Floyd Hill - Early Projects
ALIVE ITF Meeting
July 12, 2021, 1:00 PM to 3:00 PM
Virtual - Google Meet

ALIVE Meeting #7

MP 254.5 – Genesee: Wildlife Underpass

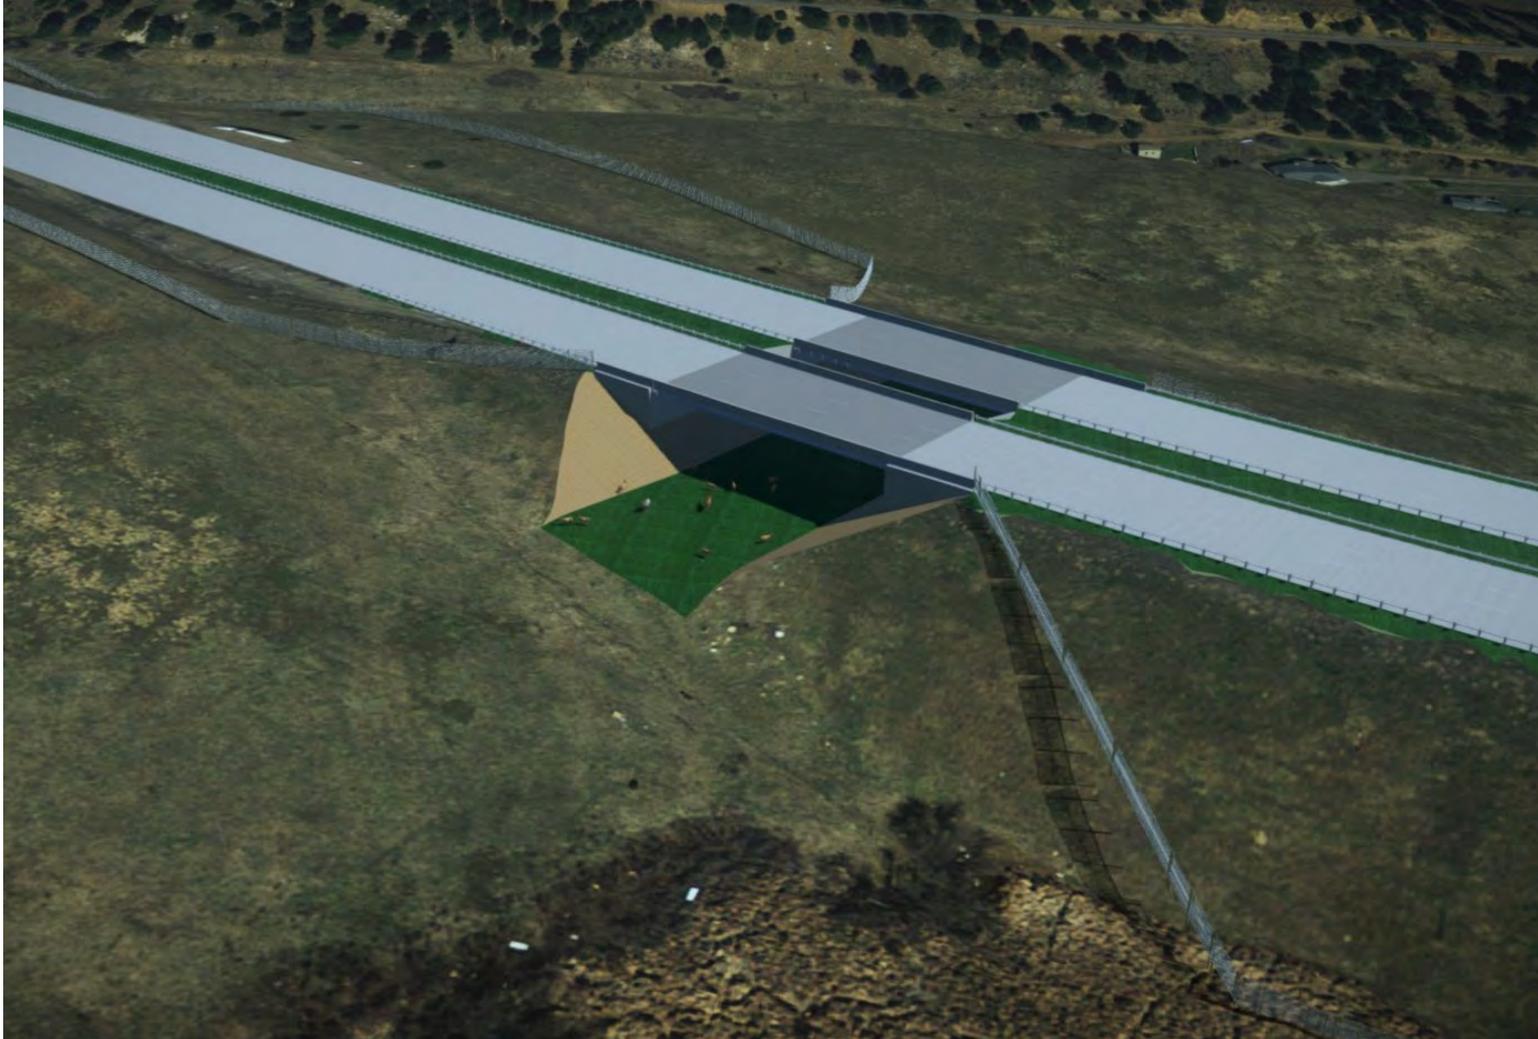
Question: What about the median space? Would it create issues with lighting or shadows that may inhibit wildlife use?

Question: Is there PMJM habitat that needs to be considered? Or is it outside the elevation range?

Answer: In this situation where we have span bridges with large openings, the median opening does not create a light barrier as it would in the middle of a long, dark culvert. To minimize the impacts of traffic noise and headlights through the median opening, concrete walls (e.g., jersey barriers) will be placed around all four sides of the median opening.

Answer: It's about 7,300-7,400 feet in elevation, so is within the higher end of the elevation range. Francesca Tordonato, CDOT, noted that the drainage on the north side is quite degraded with little shrub cover. Also, the work will be above the drainage so habitat, if it were present, would not be affected. However, fencing associated with the underpass may cross other drainages and there has been little trapping in the area, so it will be important to review the potential habitat in more detail.

US 40, MP 257.4 – Empire: Wildlife Overpass

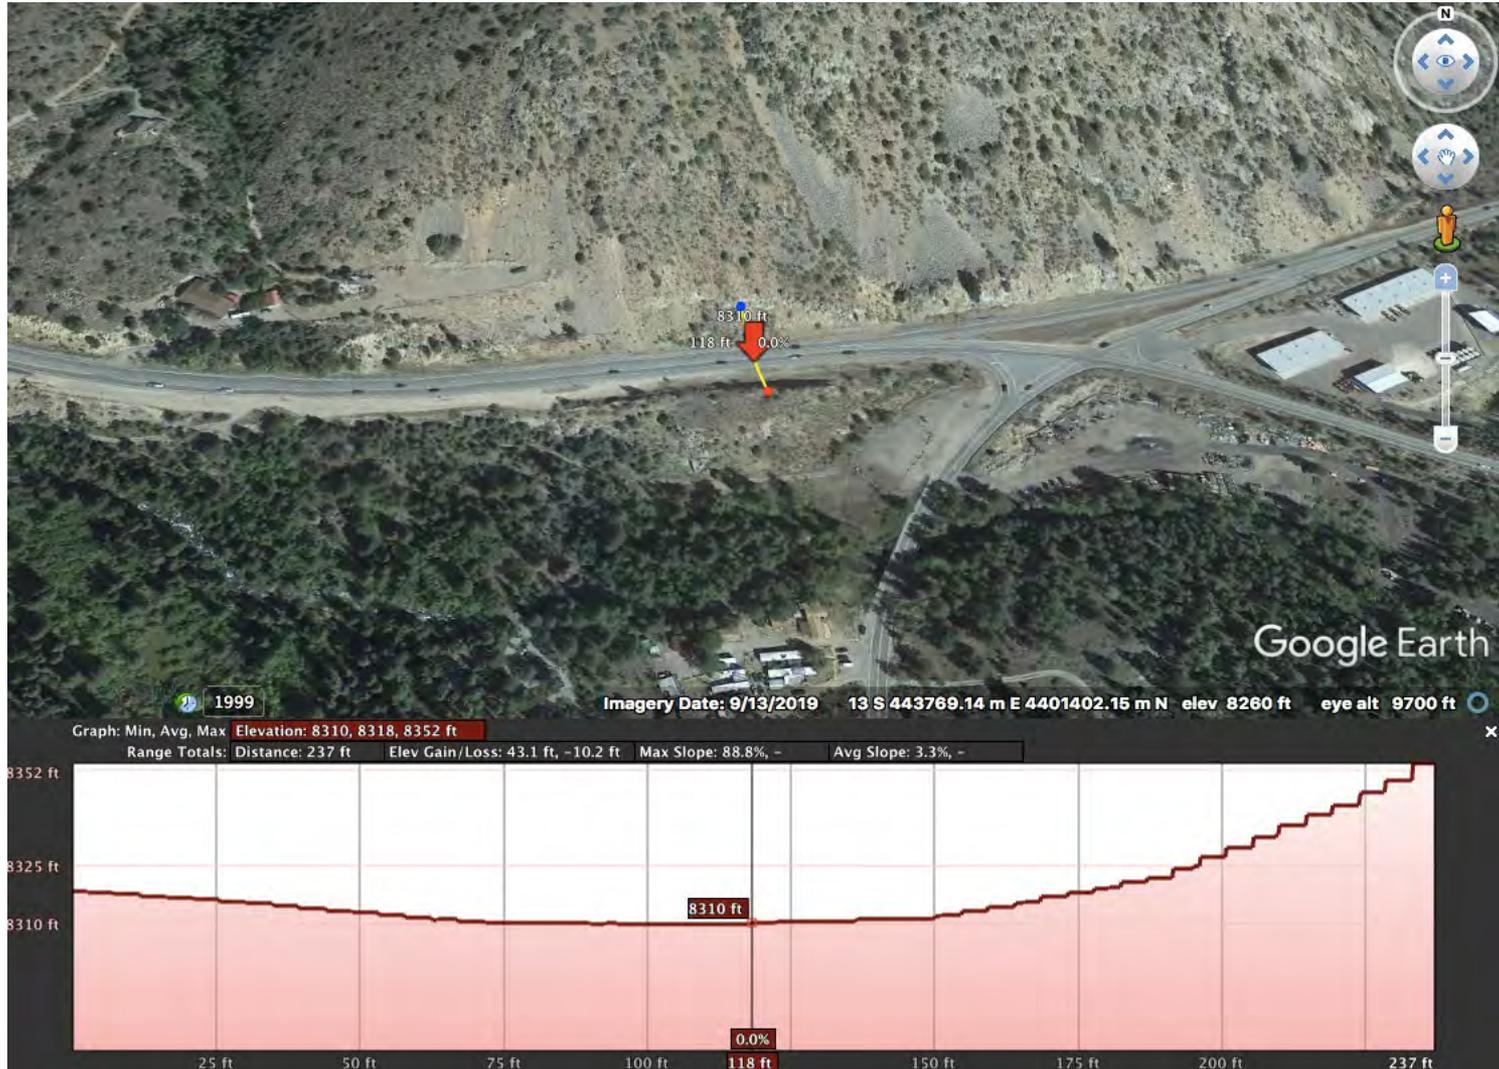
Question: Will the fencing be rockfall fencing, and how will it be maintained?

Question: Would the location or design be affected by the future reconfiguration of the Empire Junction interchange and ramps?

Question: Will the crossing encourage sheep use and potentially create issues with WVCs on I-70?

Question: Are there any issues with escape ramps and how often do they occur on the east side of the crossing (the pink area on the map)?

Question: Is there a concern with the area that looks like an avalanche chute northeast of Empire?

Question: On the KMZ, it looks like the proposed fencing stops short of CR 255. Are there two fencing options in this area?

Answer: Yes, the fencing on the northwest side of the overpass is likely to be rockfall fencing so that it is more durable and easier to maintain along this cliffy stretch. The fence would still be 8' high but would be different than traditional wildlife fencing. Guardrail will also likely be required through this section. There must be room behind the fencing for CDOT maintenance to access and remove rocks. Elsewhere, the fencing will be standard wildlife fence with wood posts.

Answer: We looked at the likely footprint of Empire Junction and think the crossing would be outside of the future construction area. CDOT also looked at the AGS alignment and stations and think those will fit as well.

Answer: The purpose of this crossing structure is to provide east-west connectivity across US-40, along the north side of I-70. Movements to the south are more about accessing roadway salts on I-70 than accessing habitat on the other side. This project may not fully address the WVC concern on I-70 and specifically, the CR 257/I-70 on ramp.

Answer: The general guideline is 4 ramps per mile, which works out to about every 0.5 miles alternating between the two sides of the roadway. We have not gotten into the details of placing of ramps but those will be a consideration after the fencing is set/worked out.

Answer: This would be good to discuss with CDOT maintenance to determine whether there are any avalanche concerns in this area.

Answer: This is a mistake in the KMZ; fencing is intended to continue to CR 255.
